Addendum No. 03

The Corporation of the Town of Iroquois Falls
Waste Water Treatment Plant Effluent UV Disinfection Upgrades
EXP Project No.: NWL-23008853

Issued: March 31, 2025

Prepared By: EXP Services Inc.

DESIGNED	SCALE
CS	NTS
DRAWN	PLAN No.
TCW	23-1266
CHECKED	DRAWING No.
FE	E-02

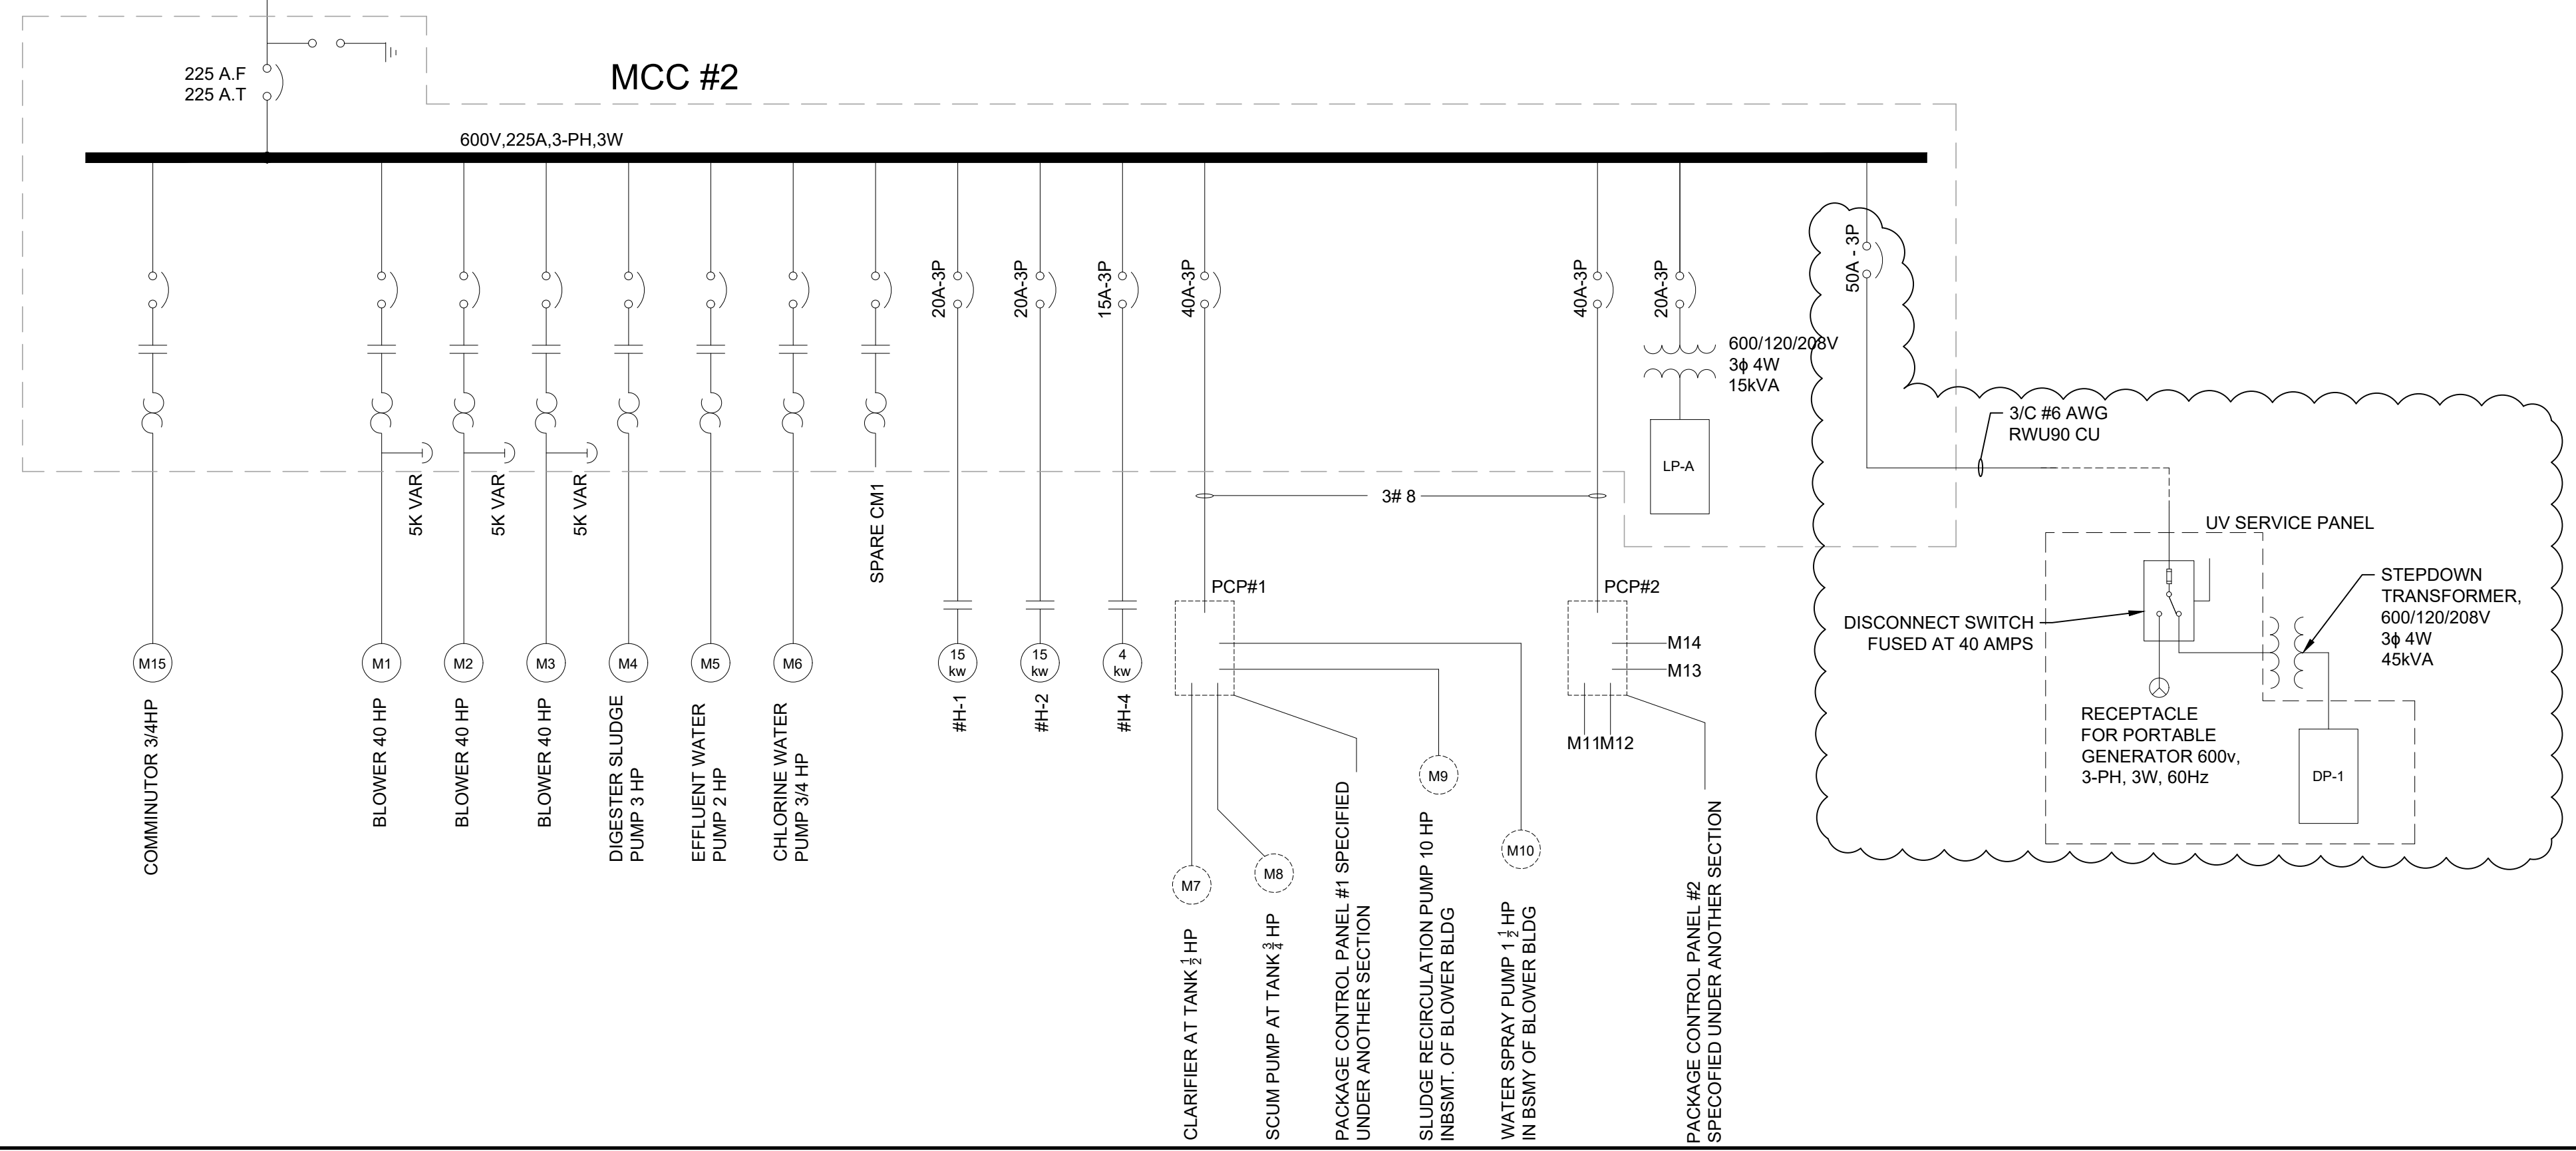
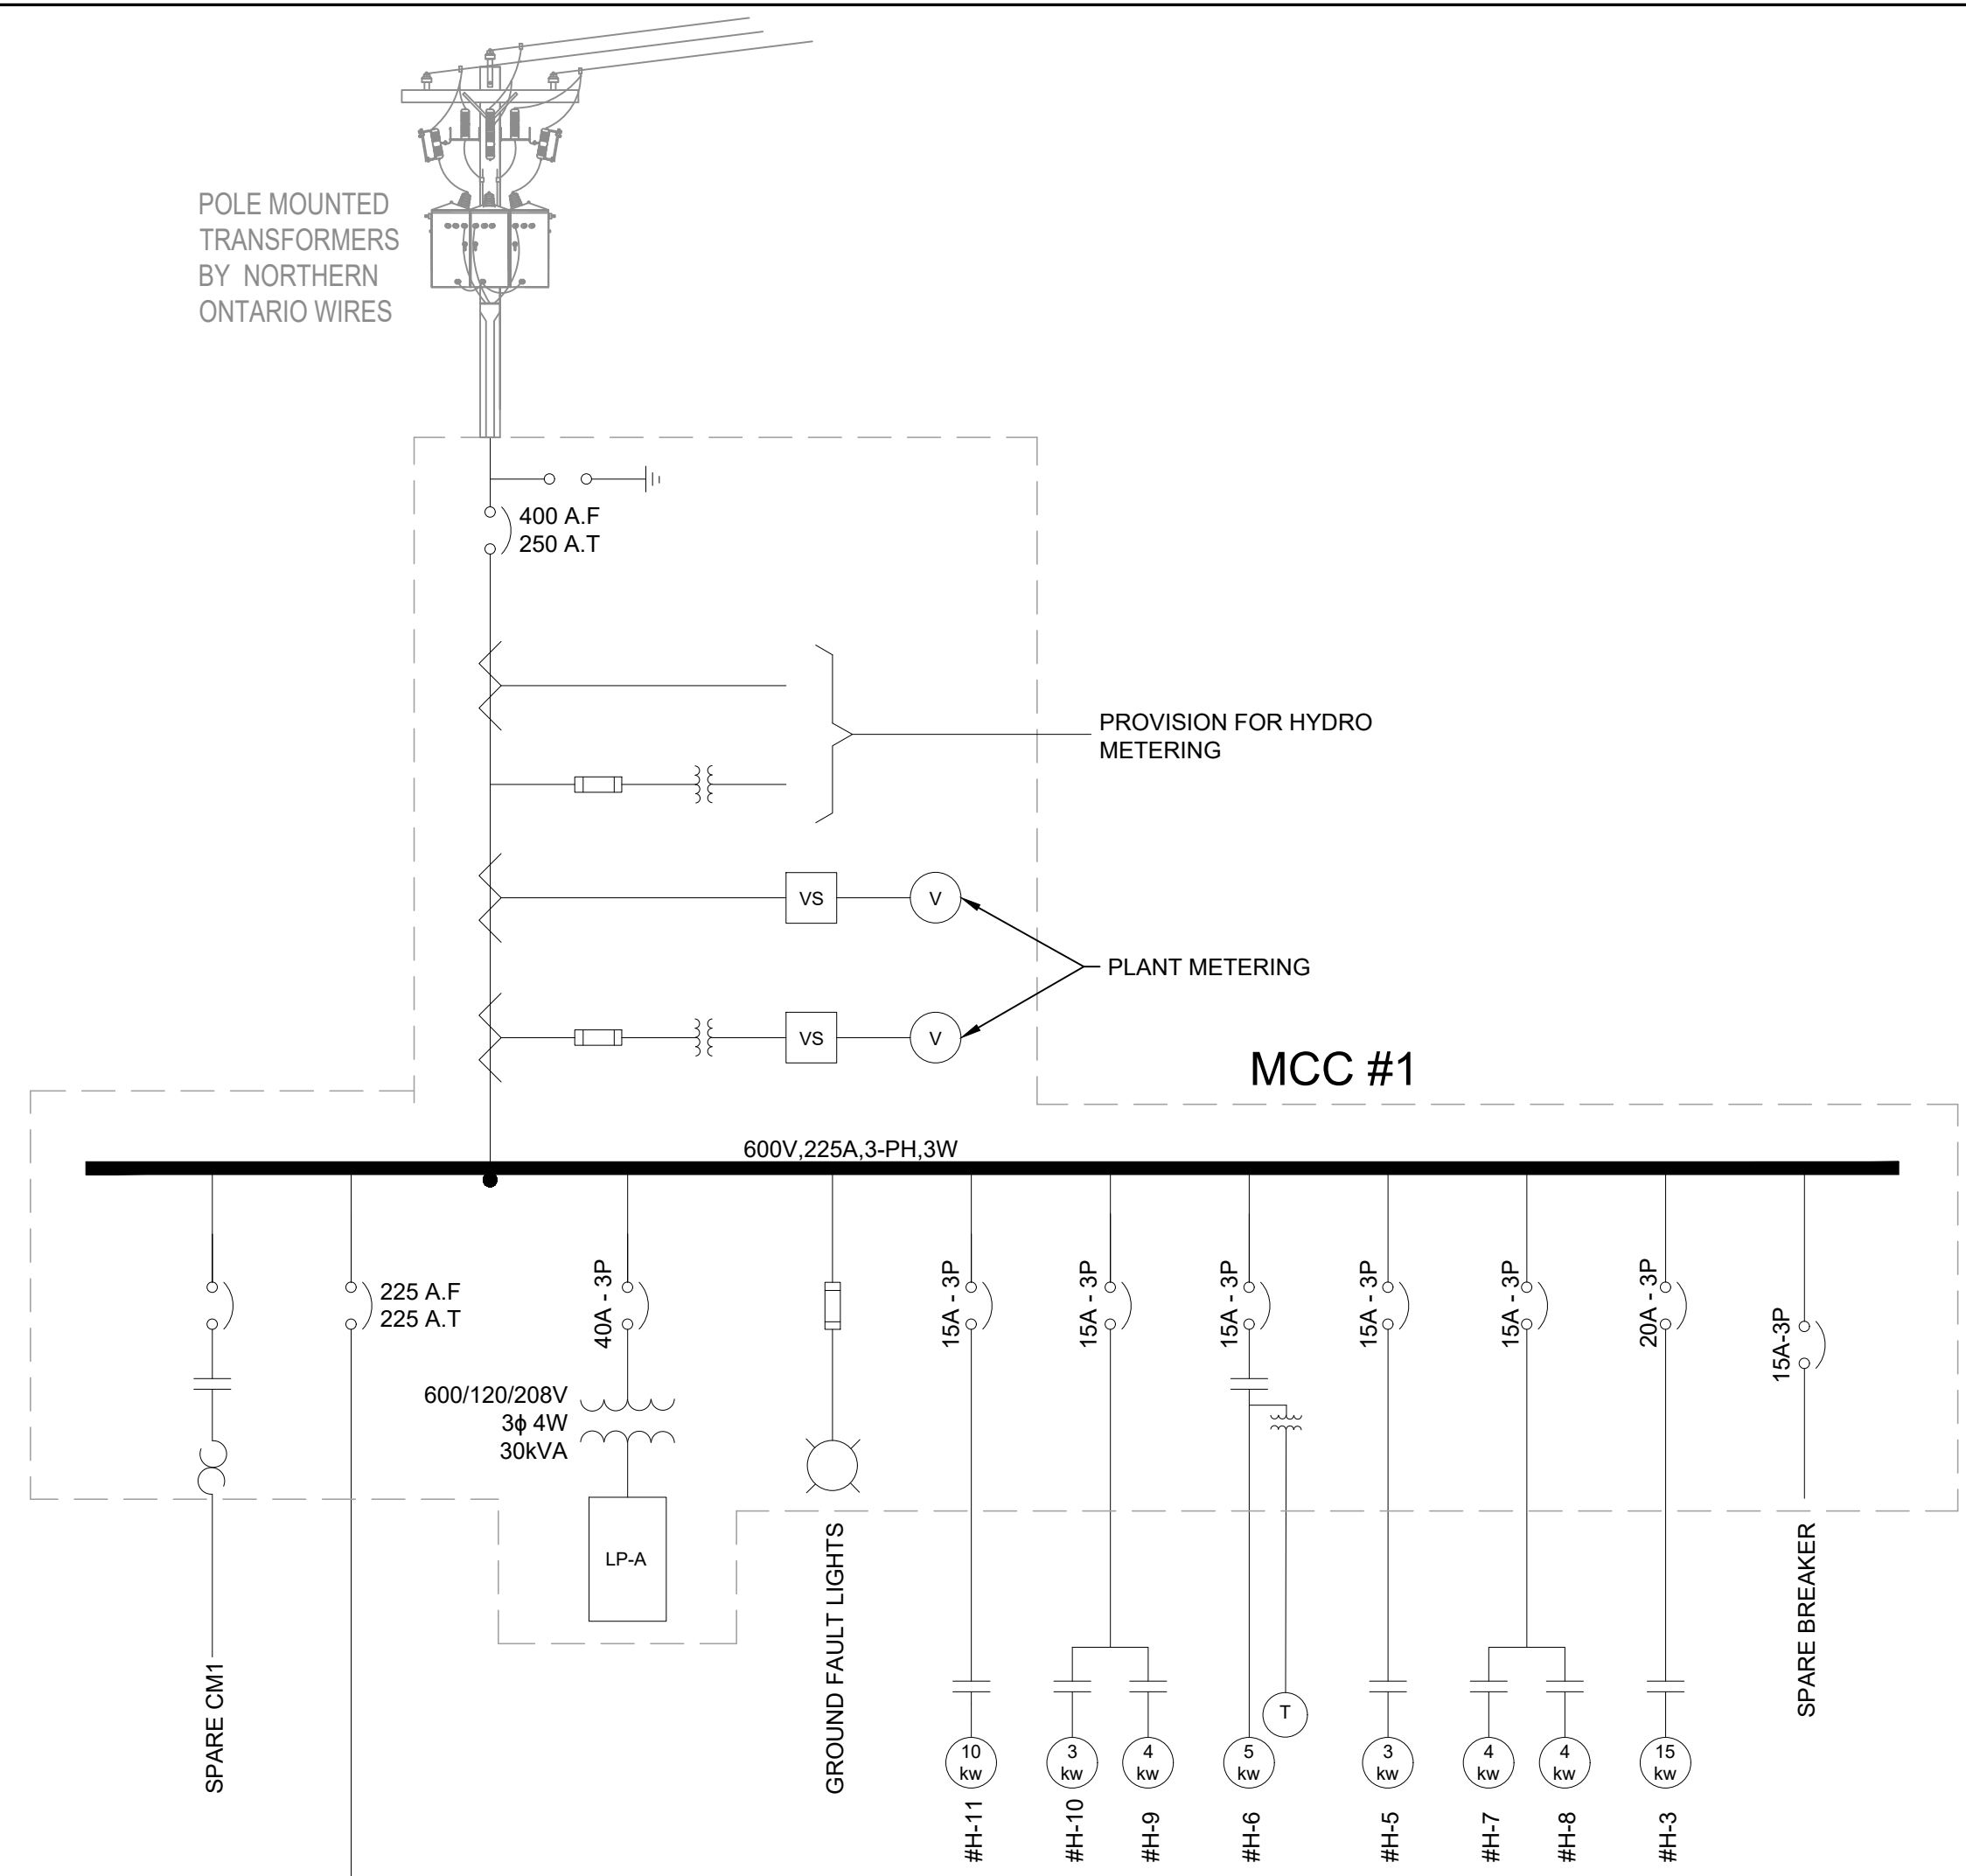
7. On Drawing E-02, Note 2, "to provide new 50 Amp circuit make Allen-Bradley or approved equal." The photos of the site show an Eaton MCC (MCC # 2?)

8. Is the required power for the UV panel from an Allen-Bradley MCC or an Eaton MCC?? RFI regarding the panel DP-1, from our suppliers: *I still cannot do the 3P 45A breakers at either 22ka or higher as they are not available. Only 10Ka rated. I can do series rated but the main breaker will need to be electronic adjustable trip. (will be more \$\$) In 22Ka rating I can do either 3P 40 or 3P 50A*

Drawing E-02 has been revised for clarity.

The Contractor is required to coordinate with the supplier of system during the Shop Drawing phase to confirm. The Contractor is to include in a price for a 40A 3P breaker at proper rating as per electrical specifications and drawings.

2. PROVIDE NEW 50A CIRCUIT BREAKER, MAKE ALLEN BRADLEY OR APPROVED EQUAL. UV SERVICE PANEL TO GO INTO EMPTY SPACE WITHIN MCC PANEL. CONTRACTOR WILL BE REQUIRED TO SUPPLY HARDWARE AND BUCKET FOR THE MCC UNIT INSTALLATION. SEE DRAWING E-1 (ELECTRICAL SITE PLAN) FOR ROUTING AND DUCT BANK DETAIL.
